Figure 2 1% AEP Flood Levels and Flood Protection Provisions along Railway Road Frontage
Note: the above 1% AEP flood levels are considered conservative, as they assume NO flow in the underlying pipe system in Railway Road.

1% AEP Flood Levels and Flood Protection Provisions along Whitehorse Road Frontage

From: Cheryl Rossington
Sent: Tuesday, 26 February 2019 3:04 PM
To: 'James Lee'
Subject: Minimum Floor Levels Application - 160 Whitehorse Road Blackburn

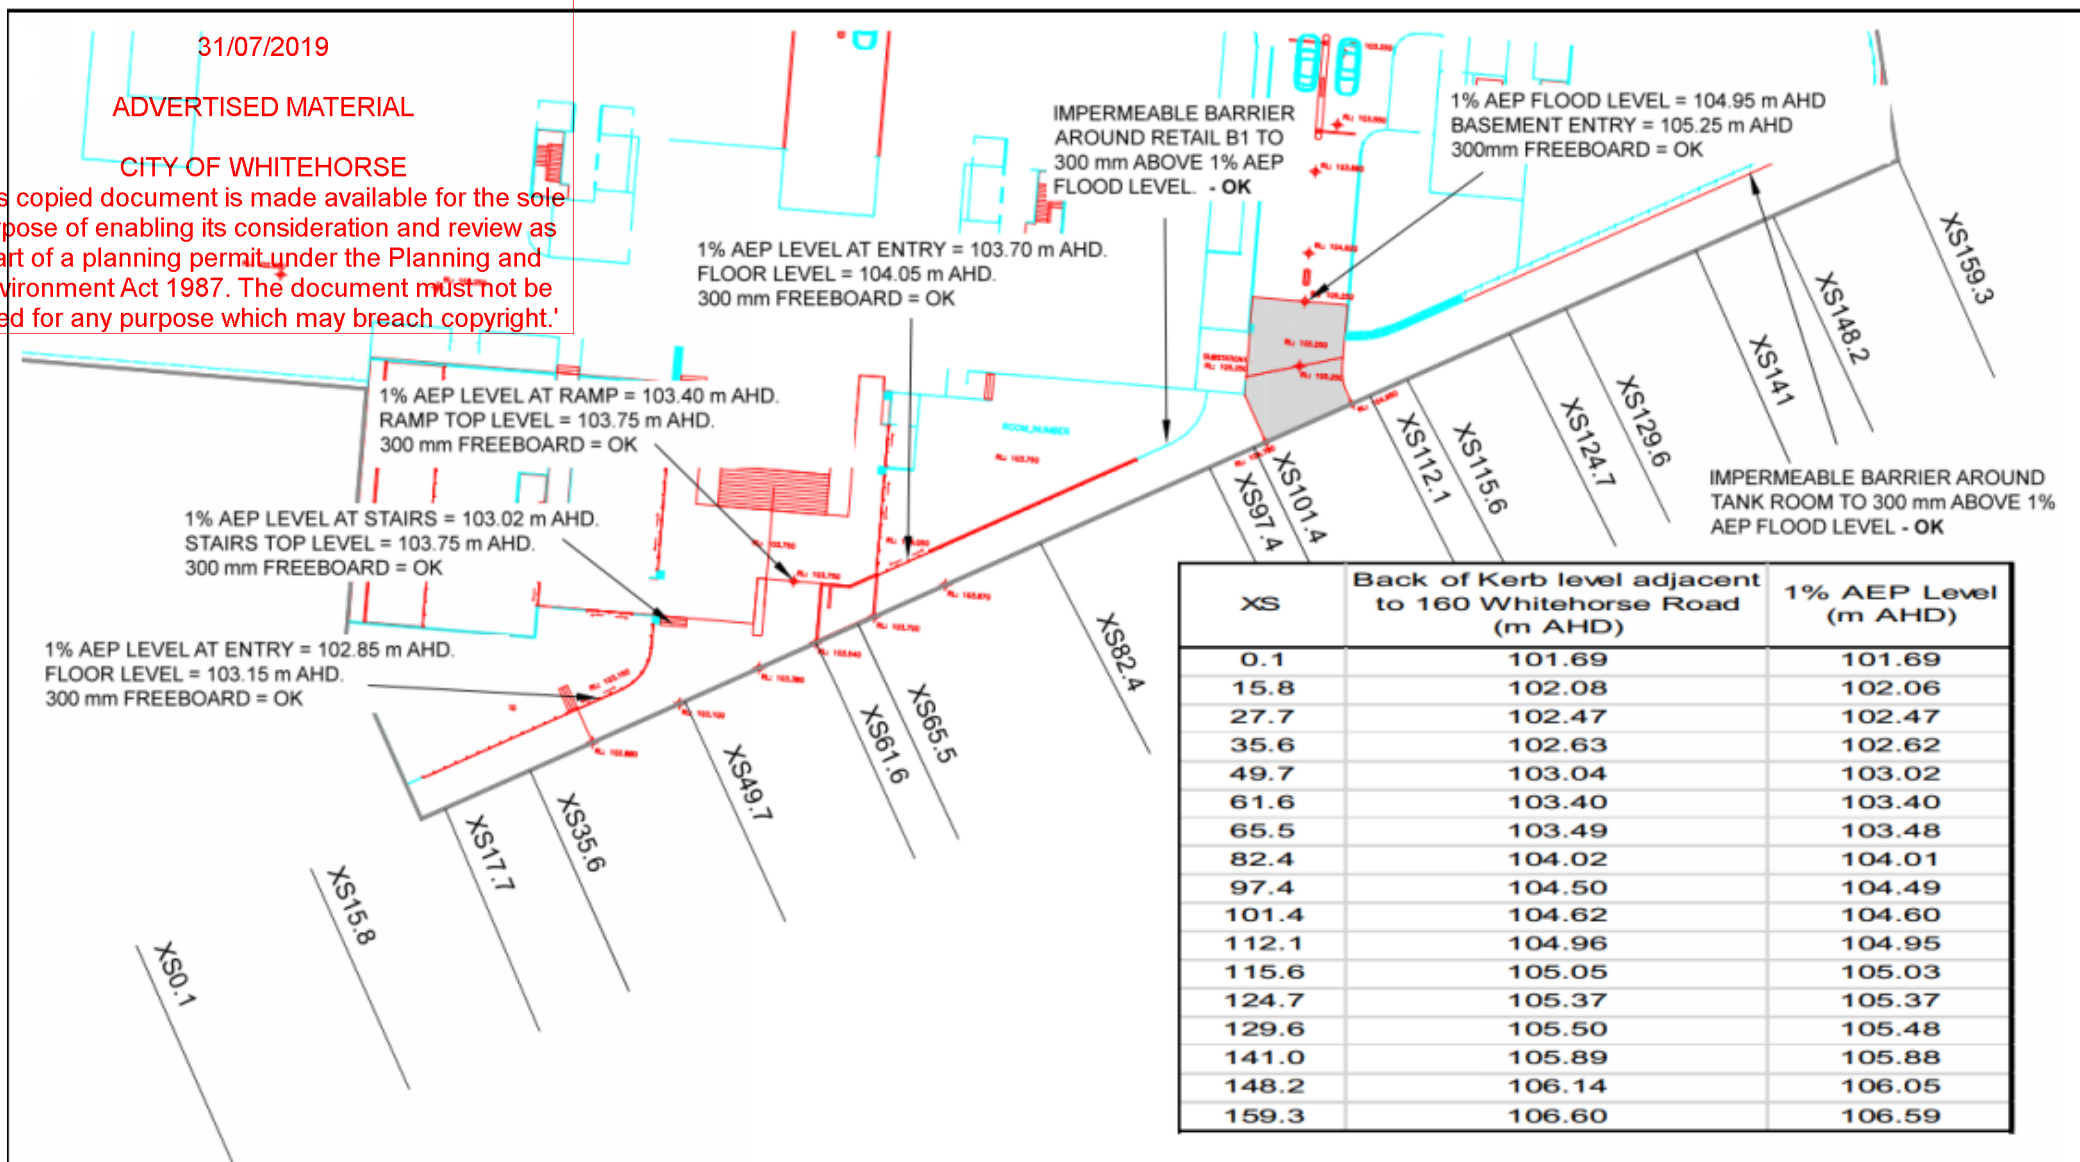
Please note that any mitigation methods including the planter boxes must be constructed to at least 1% AEP flood level plus 300mm.

I've marked on the elevation plans here the intent and level of the barrier along the façade on Railway Parade. These will be set at a min. 0.3m + (applicable) flood level as per our discussions (Refer to Page 3).

I am satisfied with the habitable floor levels that you have shown on the plans.

Figure 3

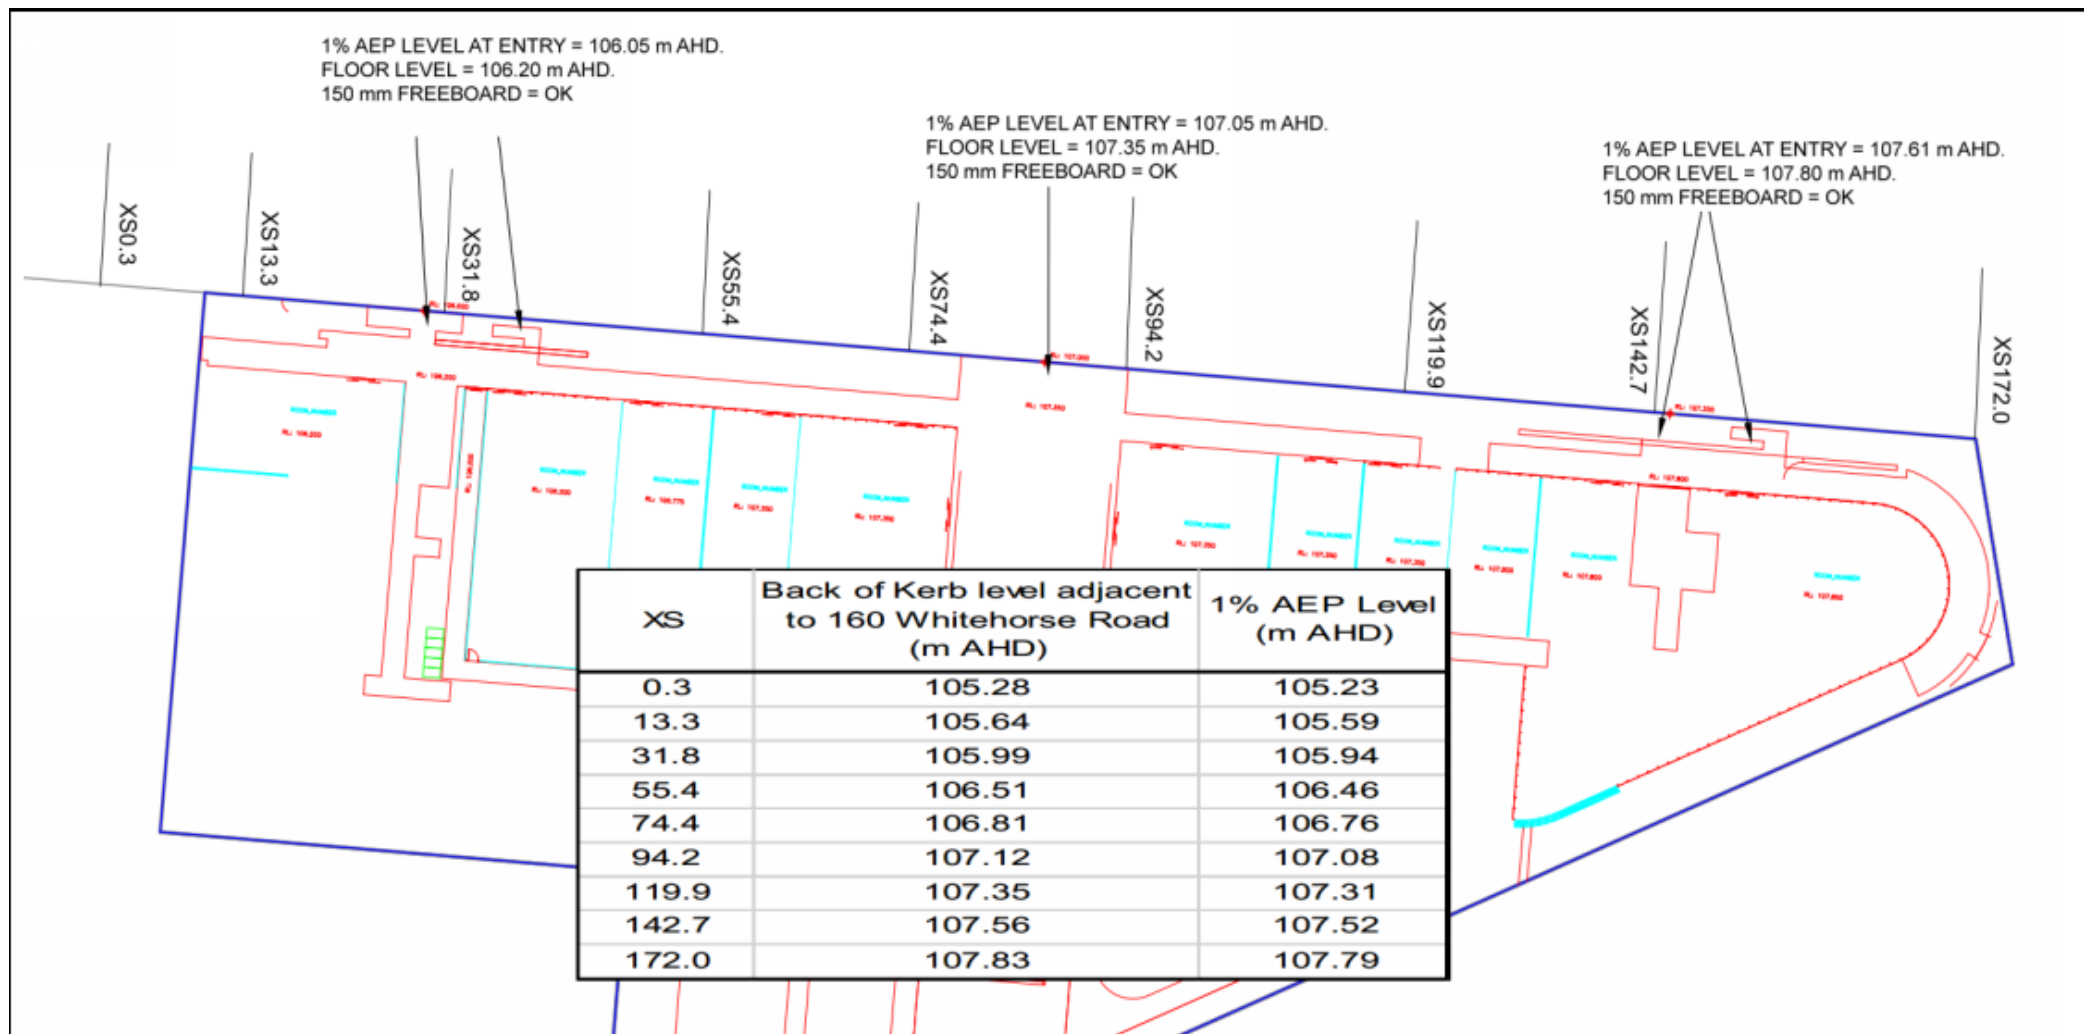
- Habitable areas of the proposed development (Commercial and Residential) along Whitehorse Rd frontage will be at a minimum 300mm above the identified flood levels along Whitehorse Rd and Railway Rd in accordance to the Building Regulation
